Job 72411171REP1	Truss A5	Truss Type Truss	Qty 5	Ply 1	HH Hunt\CHATHAM FRMH A RF MR SP 3CG Job Reference (optional)
---------------------	-------------	---------------------	----------	----------	---

Repair for loose plate at joint 12 and 11

Job 72411171REP1	Truss B3	Truss Type Truss	Qty 3	Ply 1	HH Hunt\CHATHAM FRMH A RF MR SP 3CG Job Reference (optional)
---------------------	-------------	---------------------	----------	----------	---

Repair for loose plates at joints 4, 5, 11, and 9.

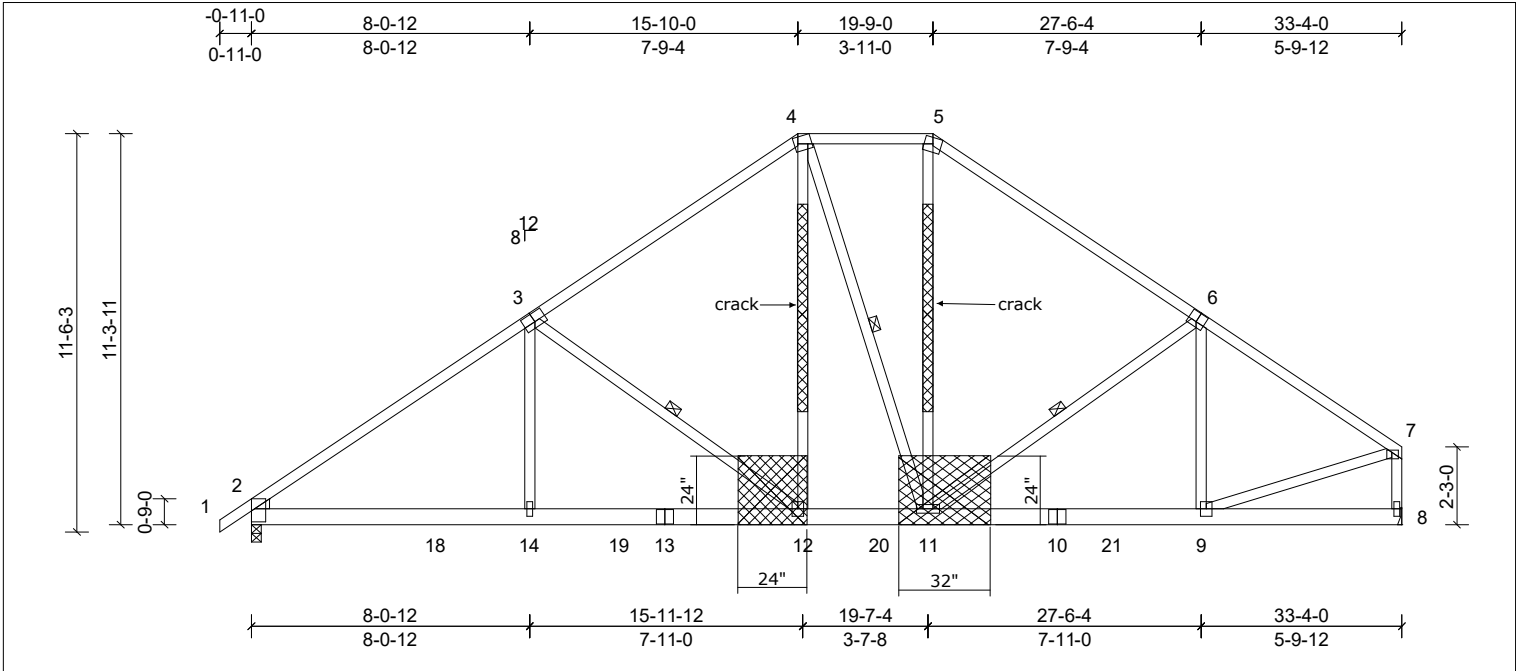
Repair for a crack in the webs where indicated.

Attach 1/2" Plywood or 7/16" OSB (APA Rated Sheathing Exposure 1) gusset to both sides of truss as shown with two rows of 10d (.131" x 3") nails spaced 4" oc in all members from each face, driven through both sheets of plywood.

Attach 2x4 x 6' SP or SPF No.2 scab to each face of truss centered on crack with 2 rows of 10d (.131" x 3") nails spaced 4" oc.
